Edwin I. Hatch Nuclear Plant - Unit 1
Response to Request for Additional Information on
Request to Revise Technical Specifications:
Safety Limit Minimum Critical Power Ratios (SLMCPR)

Nonproprietary Version of the RAI response

**Responses to REQUEST FOR ADDITIONAL INFORMATION
 RELATING TO AMENDMENT NO. TO LICENSE NO. DPR-57
 SOUTHERN NUCLEAR OPERATING COMPANY
 EDWIN I. HATCH NUCLEAR PLANT, UNIT 1
 DOCKET NO. 50-321**

Figure 1 Reference Core Loading Pattern – Cycle 20

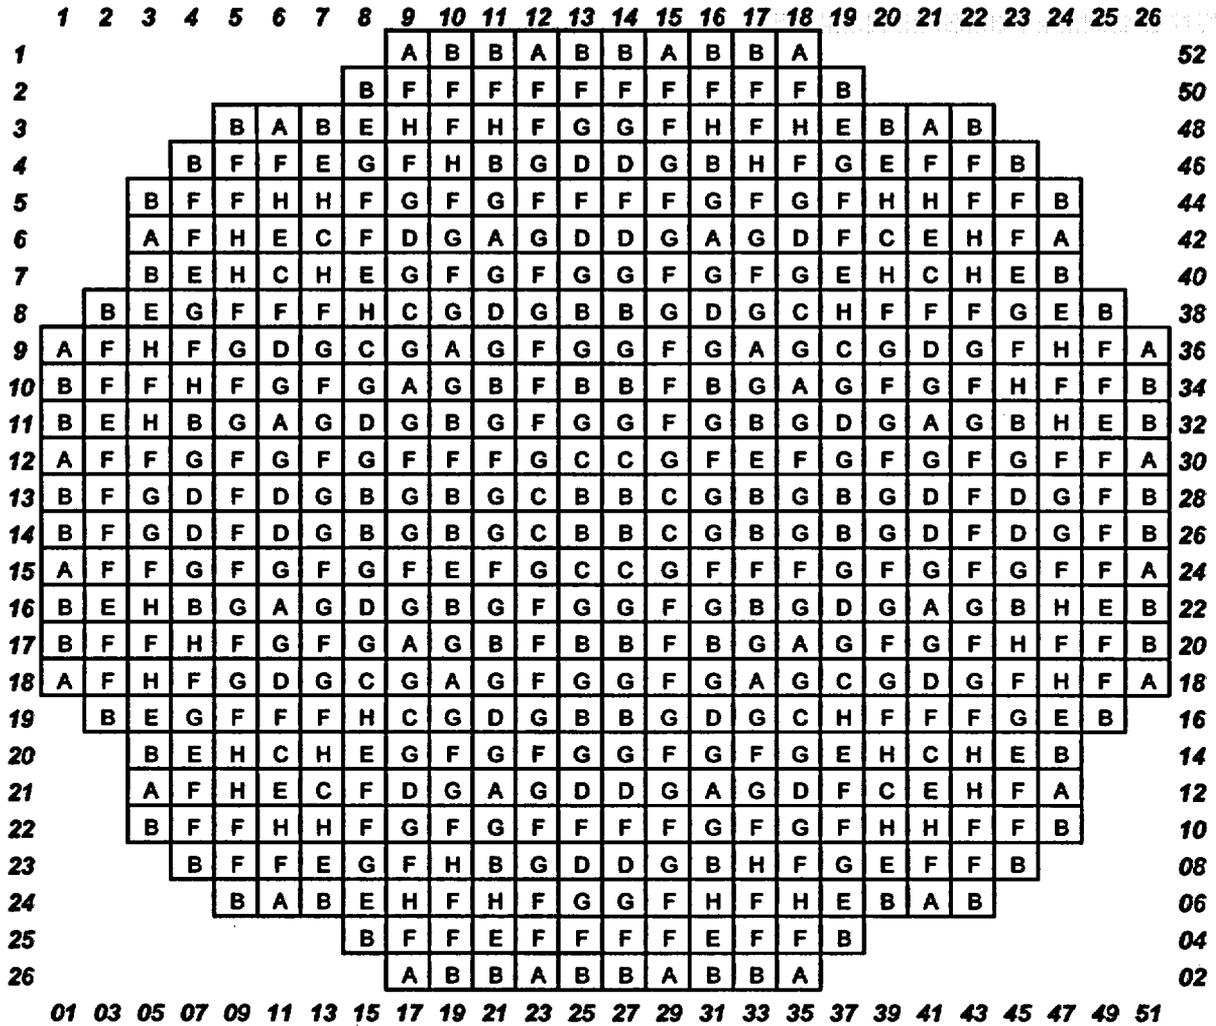
1. Figures 1 and 2 for Cycle 20 and Cycle 21 Reference Core Loading Pattern, respectively, should be updated to include quantity of fuel assemblies, and when those assemblies are loaded in the core.

Updated figures of the core loading patterns are provided which include the quantity of fuel assemblies and the cycle in which those assemblies were first loaded in the core.
